TASK FORCE TIPS Technical Bulletin

ELECTRIC REMOTE WIRING CHANGE

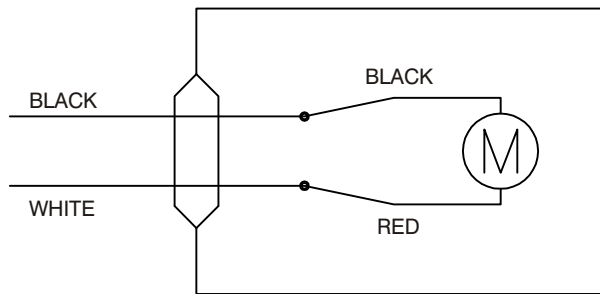
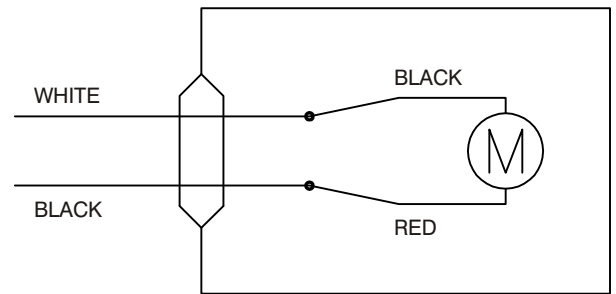
As of March, 2005 Task Force Tips, Inc. made a change to the wiring of the electric remote actuators, which reverses the polarity of the electric motor. This change was made to accommodate the design of the RC monitors.

This change affects any electric remote nozzle that is ordered without a plug.

**WIRE COLORS PRIOR
TO MARCH 2005**

**WIRE COLORS AFTER
MARCH 2005**

Please make appropriate wiring schematic changes so nozzle actuation matches control signals.
